Contract #: 04-0120F4Cty: SF/ALA Rte: 80 PM: 13.2/13.9File #: 69.25B**QUALITY ASSURANCE -- NON-CONFORMANCE REPORT****Location:** Changxing Island, Shanghai, P.R. China**Report No:** NCR-000888**Prime Contractor:** American Bridge/Fluor Enterprises, a JV**Date:** 08-Nov-2010**Submitting Contractor:** Zhenhua Port Machinery Company, Ltd (ZPMC), Changxing Island**NCR #:** ZPMC-0850**Type of problem:**

Reference Description: Lift 5 Grillage West Shaft Non-fusion Backing bar**Description of Non-Conformance:**

Subject: NCR No. ZPMC-0850

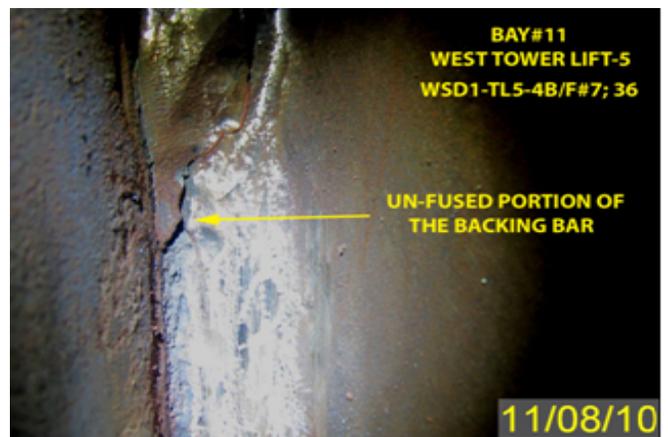
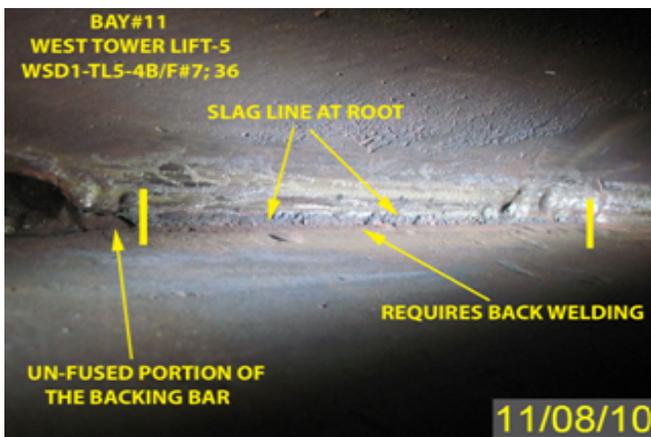
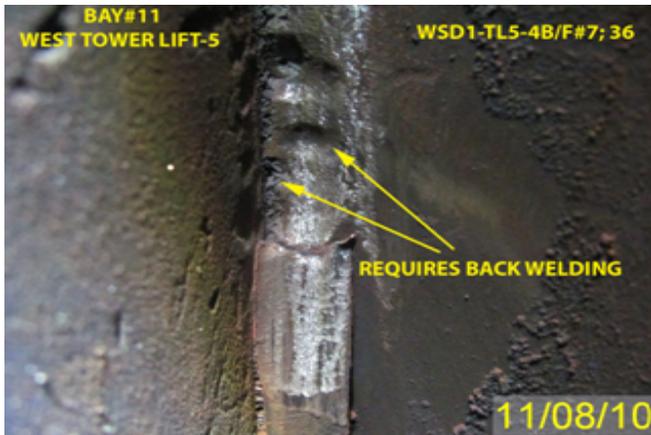
- 1) WSD1-TL5-4B/F#07; 36 – Non-fused backing bar has not been completely removed. There is a slag line at the entire visible root pass area.
- 2) WSD1-TL5-4B/F#04 – Root pass has been ground out to an average depth of 1.5mm. Back welding has not been performed.

-Welds are T-Joint Complete Joint Penetration (CJP) welds.

With the intention to close the Non-Conformance Report, NCR#ZPMC-0839, ZPMC had submitted the Notice of Witness Inspection Number (NWIT) # 007275. This repaired area has been previously tested and accepted by ZPMC Quality Control (QC) personnel. ZPMC's QC personnel performed 100% VT and MT inspection of this area.

Reference Resolution: ZPMC has repaired the areas in question and is providing the NDT to show that it is acceptable.
ZPMC has repaired the areas in question and is providing the NDT to show that it is acceptable. ZPMC requests closure of this NCR.

This proposed resolution is acceptable. The documentation received is sufficient and the Department concurs that Non-Conformance ZPMC-0850 is closed.

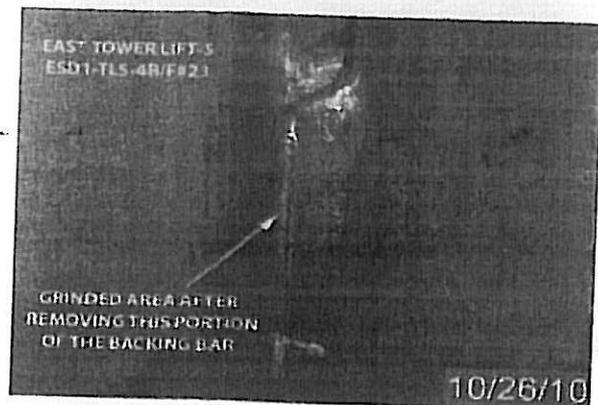
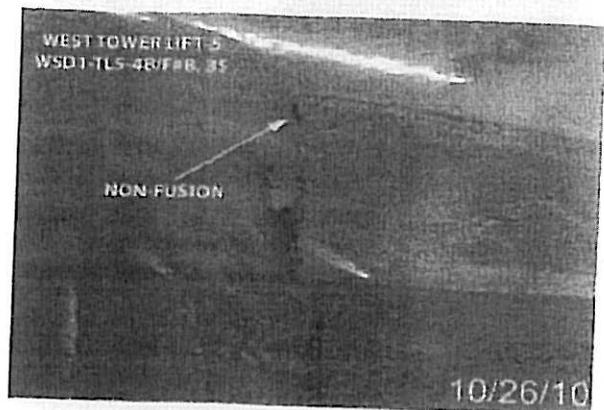
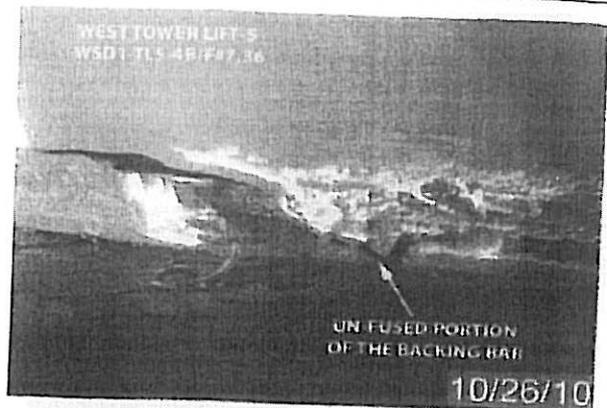
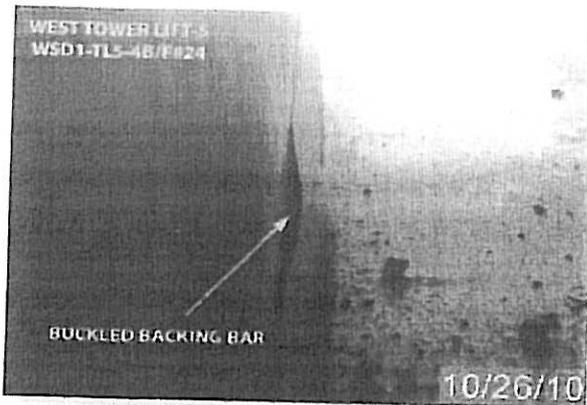
- 1) Non-Fused backing bar requires removal -joint -WSD1-TL5-4B/F#7,36
- 2) Non-Fused backing bar requires removal -joint-WSD1-TL5-4B/F#8,35
- 3) Buckled backing bar requires removal -joint-WSD1-TL5-4B/F#24
- 4) Non-Fused backing bar requires removal -joint-WSD1-TL5-4B/F#4

- 1) Area where backing bar has been removed requires back welding -joint ESD1-TL5-2B/F#23

-As per AWS D1.5 the RFI-002099R0 the groove welds made with steel backing shall have the weld metal thoroughly fused. The remaining ends of the backing bar shall be tapered in with and in depth at a slope no steeper than 1:2.5, as shown in the sketch attached with the referenced RFI.

When got these NCRs, ZPMC conducted repair work, and some welds location were fixed treated through grinding way, the others were fixed by welding.

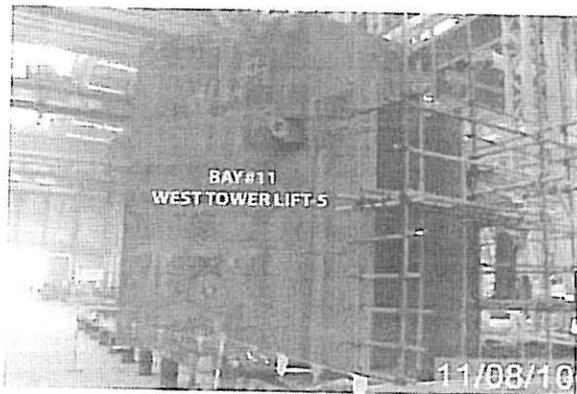
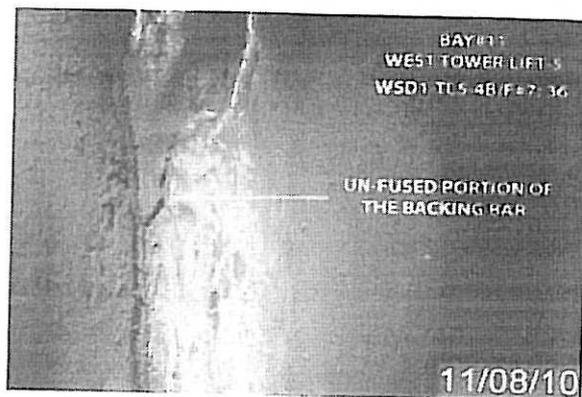
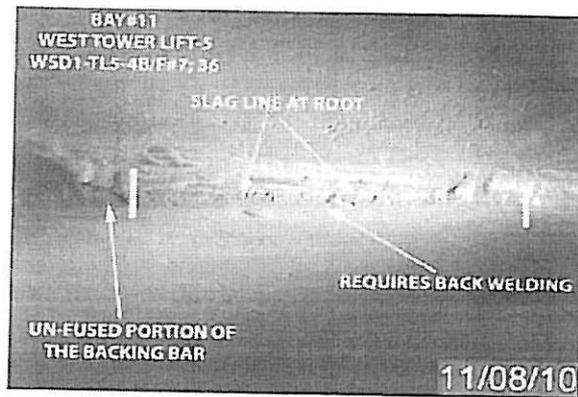
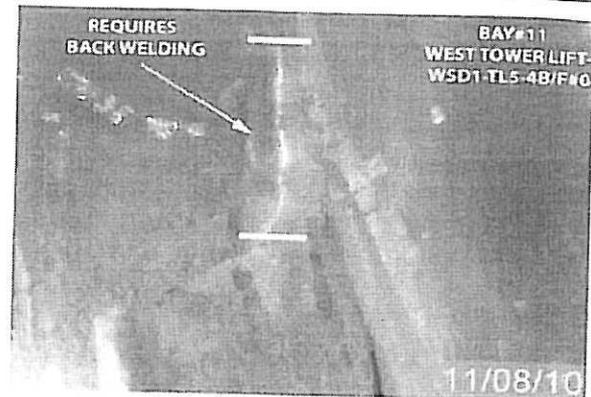
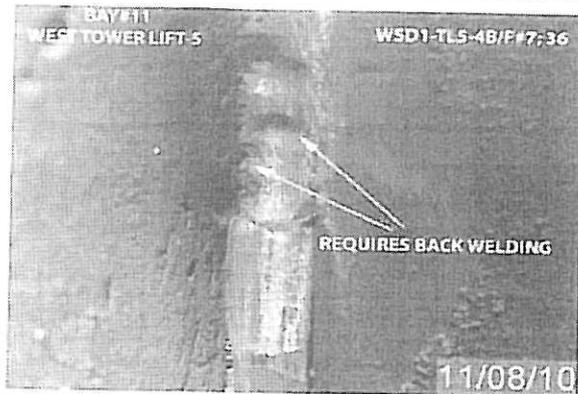
1) WSD1-TL5-4B/F#07; 36 – Non-fused backing bar has not been completely removed. There is a slag line at the entire visible root pass area.

2) WSD1-TL5-4B/F#04 – Root pass has been ground out to an average depth of 1.5mm. Back welding has not been performed.

With the intention to close the Non-Conformance Report, NCR#ZPMC-0839, ZPMC had submitted the Notice of Witness Inspection Number (NWIT) # 007275. This repaired area has been previously tested and accepted by ZPMC Quality Control (QC) personnel. ZPMC's QC personnel performed 100% VT and MT inspection of this area.
